HEAVY VEHICLE LOCAL ROAD REPORT SITE ESTABLISHMENT

Sydney Metro West – Western Tunnelling Package

Document Title	Parramatta Heavy Vehicle Local Road Report Site Establishment
Project Name	Sydney Metro West – Western Tunnelling Package
Client	Sydney Metro
Document Reference No.	SMWSTWTP-GLO-PTA-HS-RPT-000001-C.01
Revision Date	7 June 2022

REVIEW COMMENTS SHEET

Figure 7-2: Swept path analysis locations for site establishment phase of works

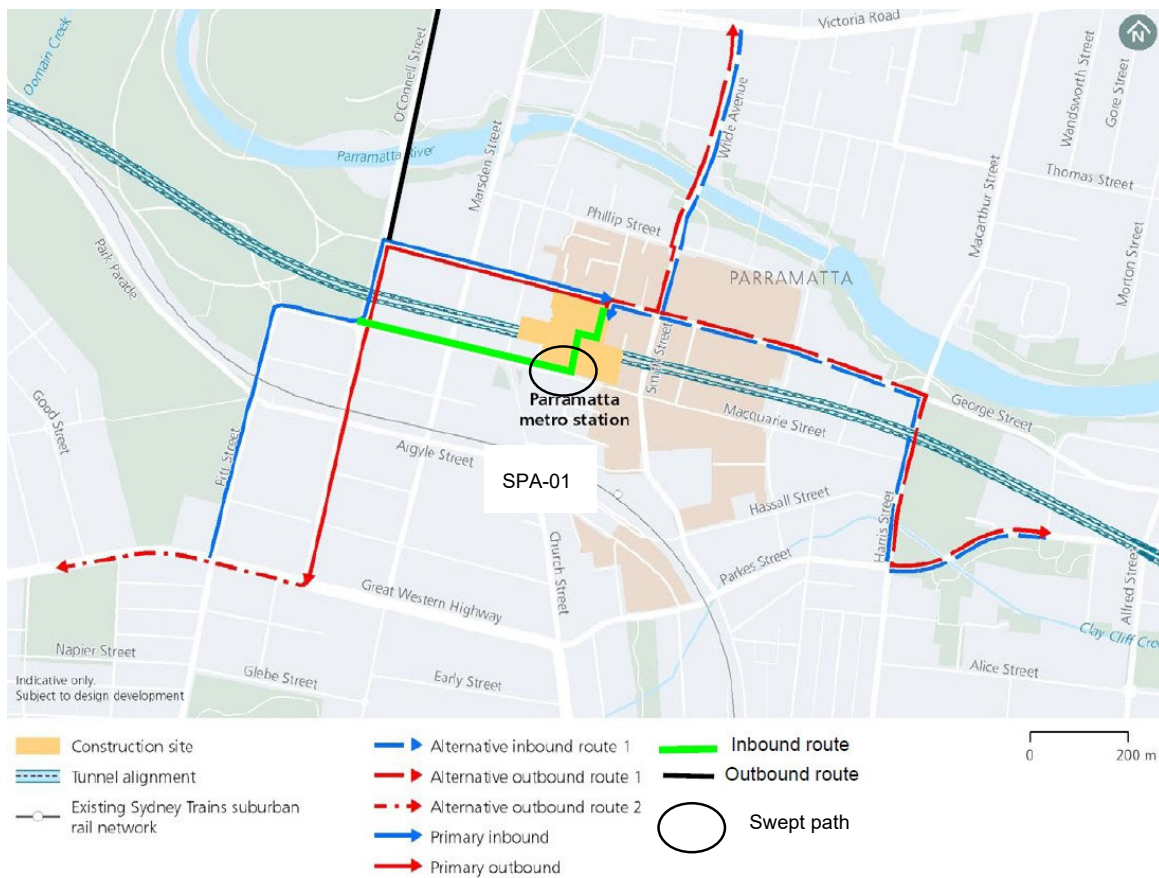
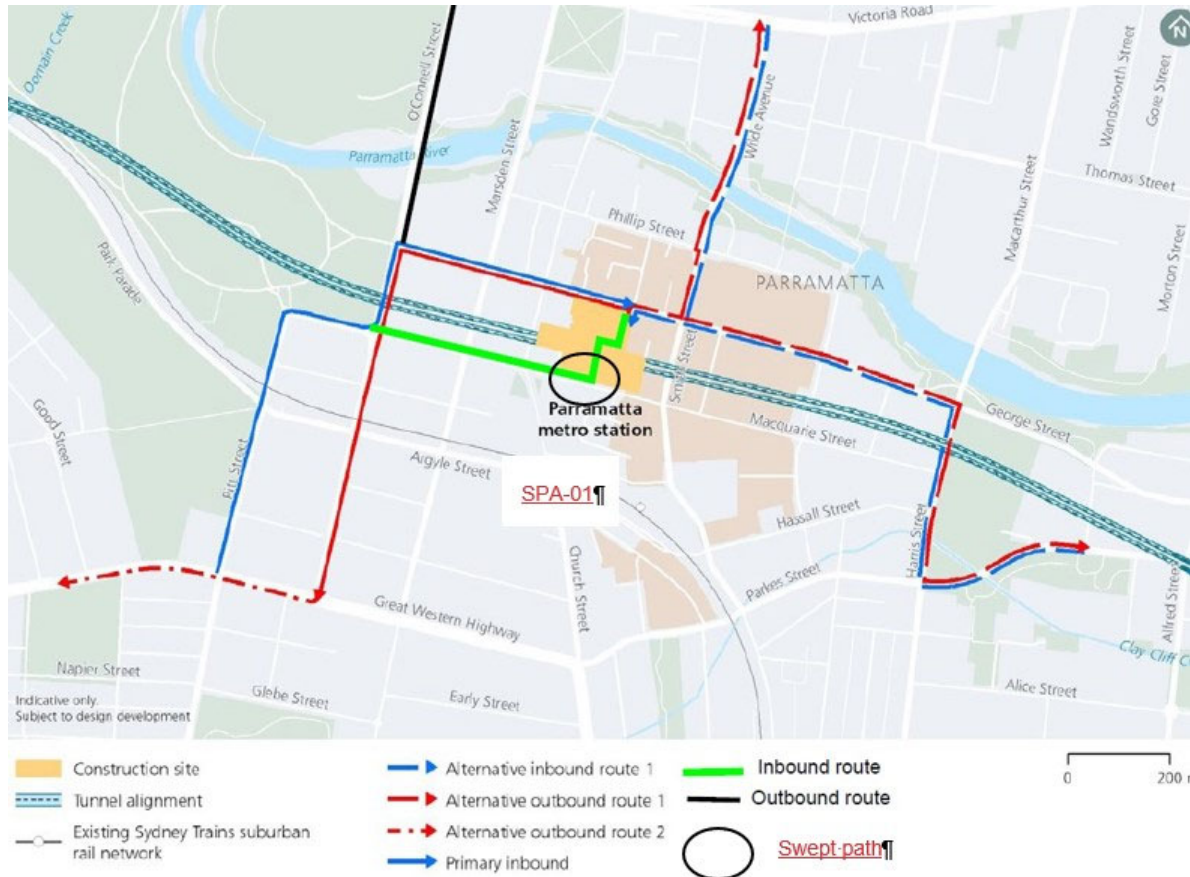
08.01.01	27/05/2022	TFN	LWILBY				Response noted, comment closed.	Observation	Y
												Observation	Y
				09	9/05/2022	SMD	BGORDON	SMWSTWTP-GLO-PTA-TF-RPT-000001	Flgure 7.2	MCoA D87	Figure 7-2 and 8-1 show the same inbound route for heavy vehicles. The outbound route/s for heavy vehicles, are two lines at the bottom of the first paragraph in Section 7.3. To improve clarity consider one map shewing all routes, maybe even an overlay of inbound and outbound routes over the EIS route map, allowing a clear comparison.	Observation	N
								SMWSTWTP-GLO-PTA-TF-RPT-000001	Flgure 7.2	MCoA D87		Observation	N

09.01	24/05/2022	GLO	DKELLY	SMWSTWTP-GLO-PTA-TF-RPT-000001	Flgure 7.2	MCoA D87	No change to document as it is quite clear what swept paths are being undertaken	Observation	N
							DKELLY	SMWSTWTP-GLO-PTA-TF-RPT-000001	Flgure 7.2	MCoA D87	Document amended	Observation	N
				11	16/05/2022	SMD	SCLARKE	SMWSTWTP-GLO-PTA-TF-RPT-000001	Definitions/ Abbreviations	N/A	Update DPIE to DPE	Observation	Y
								SMWSTWTP-GLO-PTA-TF-RPT-000001	Definitions/ Abbreviations	N/A		Observation	Y

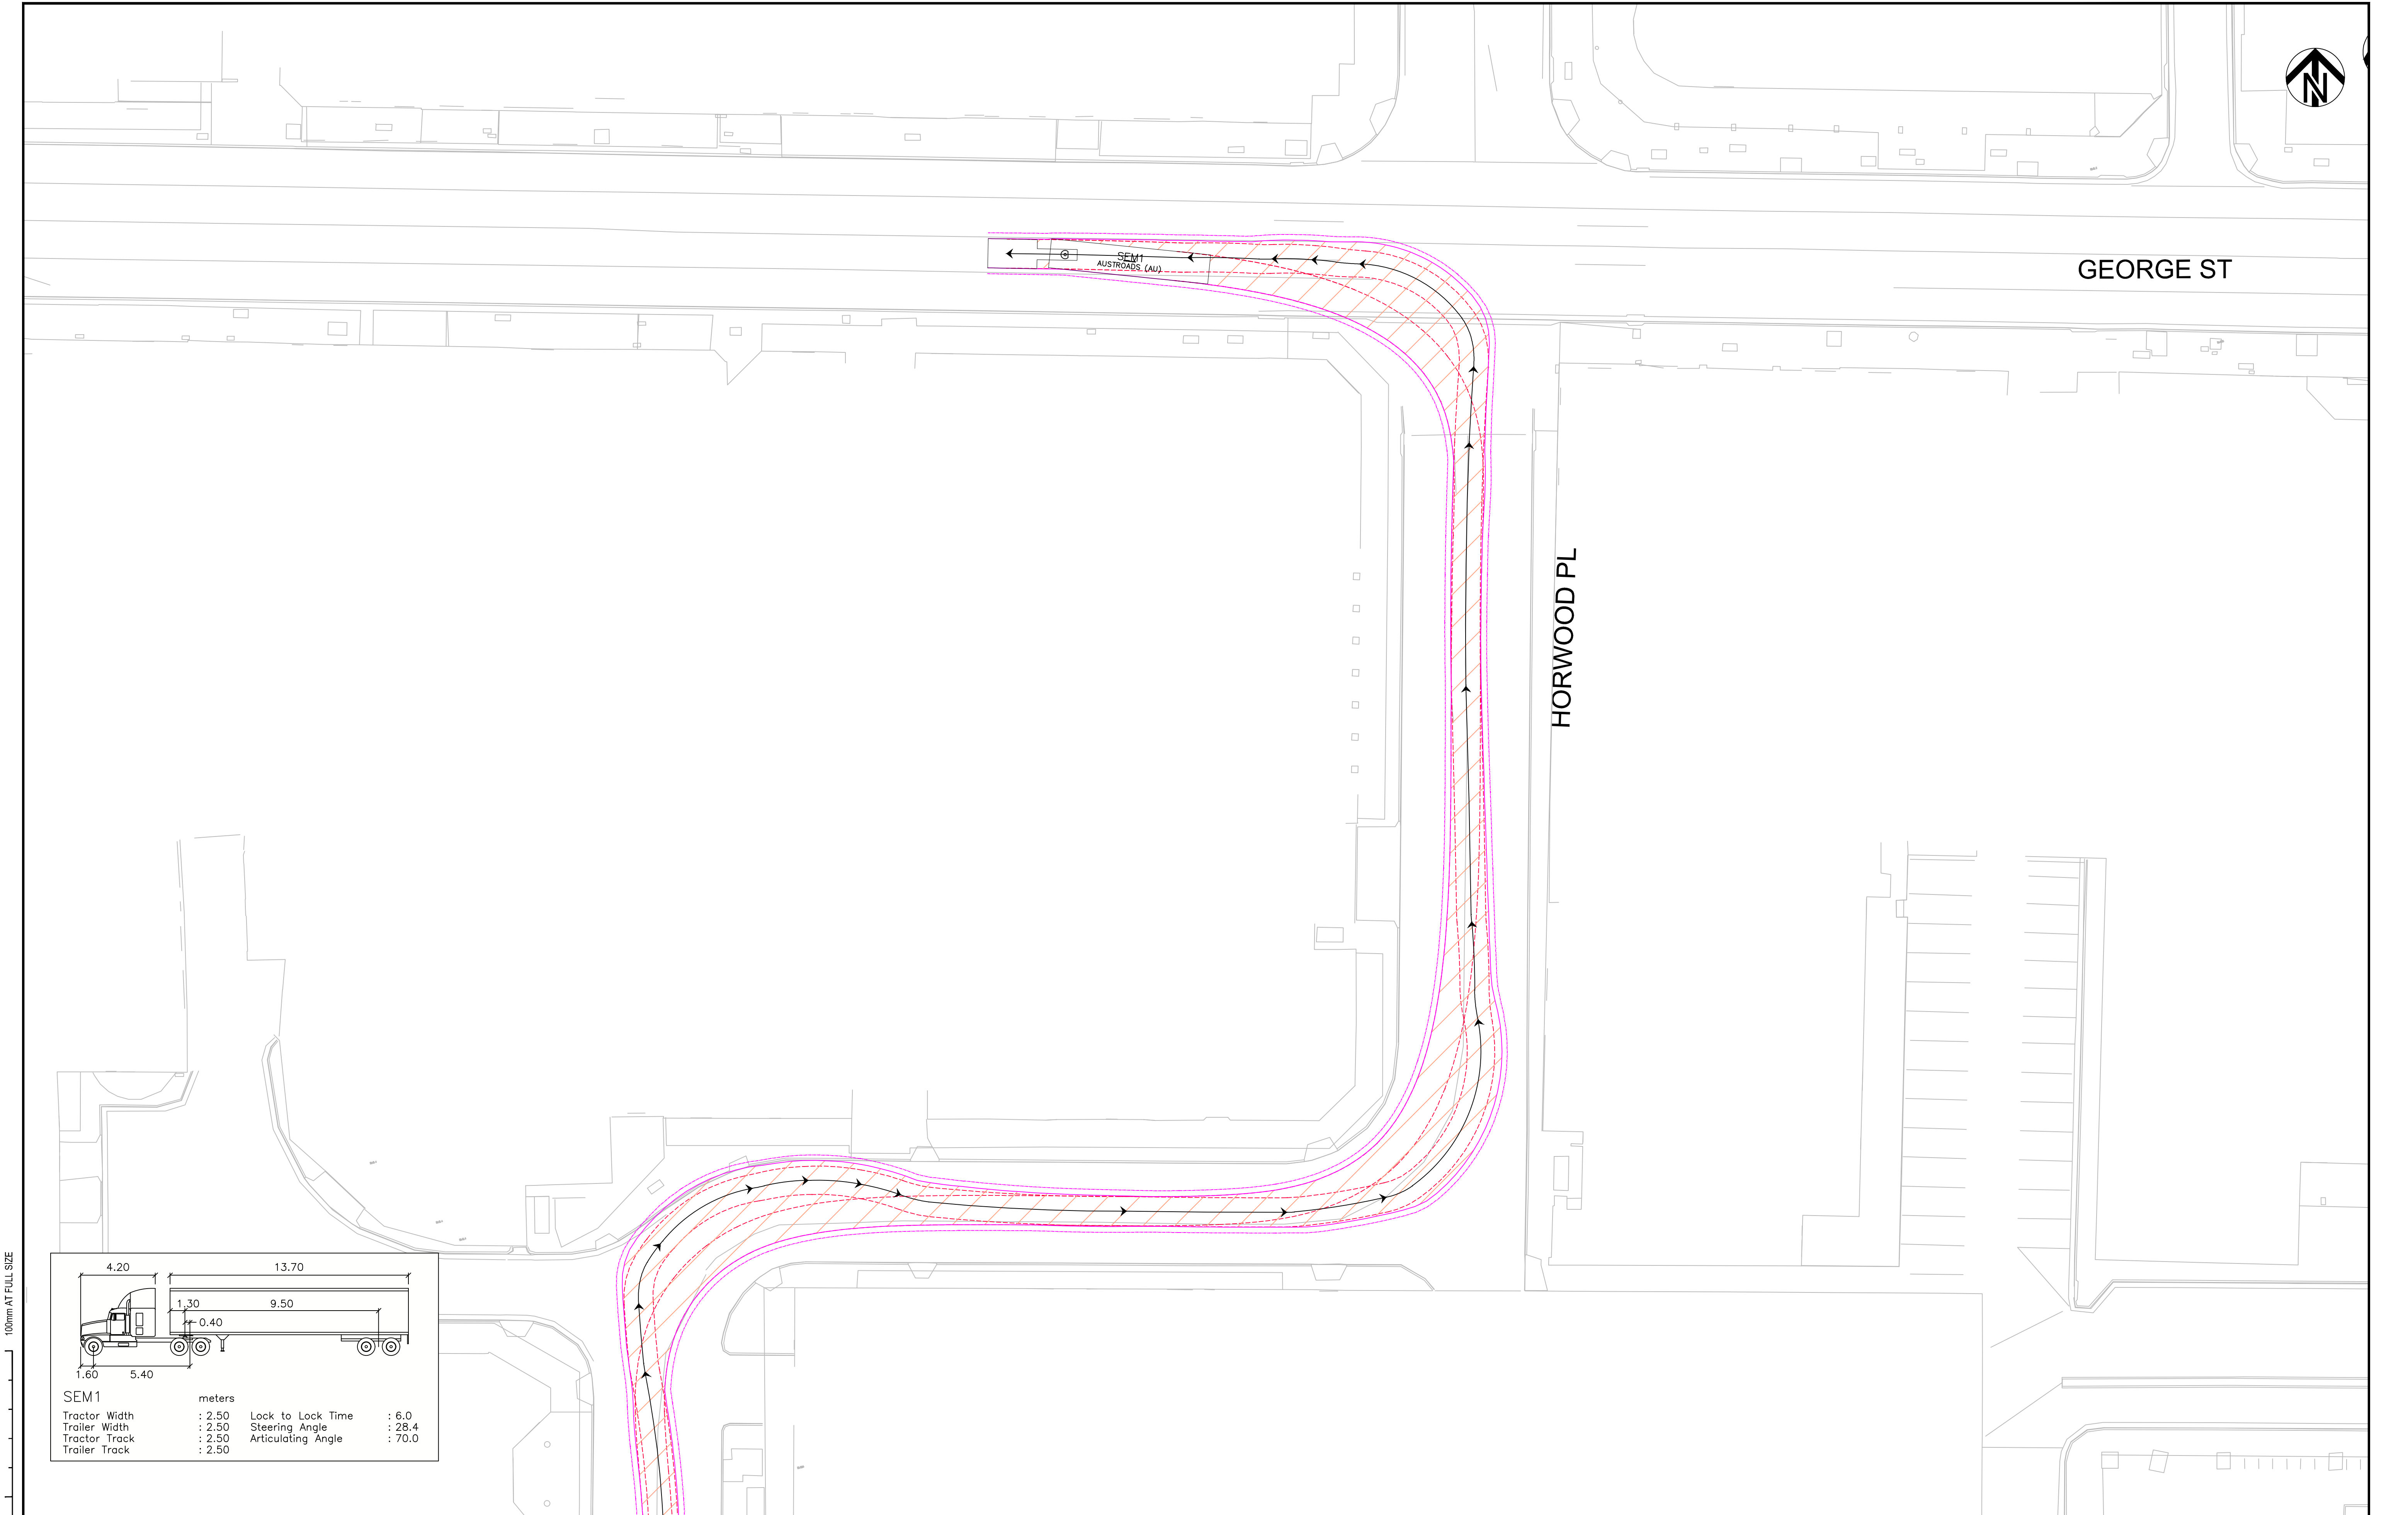
DOCUMENT NO.	TITLE	VER	STATUS	NO.	DATE	COMPANY	RAISED BY	REVIEW DOC. NO.*	DOCUMENT REF*	DEED REF*	COMMENTS / RESPONSE	COMMENT CATEGORY*	CLOSED OUT
				08	9/05/2022	TFN	LWILBY	SMWSTWTP-GLO-PTA-TF-RPT-000001	A: Swept Path Analysis	NA	The swept path for both vehicles from the left turn movement from Horwood into George Street indicates that they will either overhang the centre line or leave very little margin for error. This increases the risk of head on collision with vehicles travelling along George Street. Please consider and demonstrate what else can be reasonably done to prevent collisions in this location.	Observation	Y
								SMWSTWTP-GLO-PTA-TF-RPT-000001	A: Swept Path Analysis	NA		Observation	Y
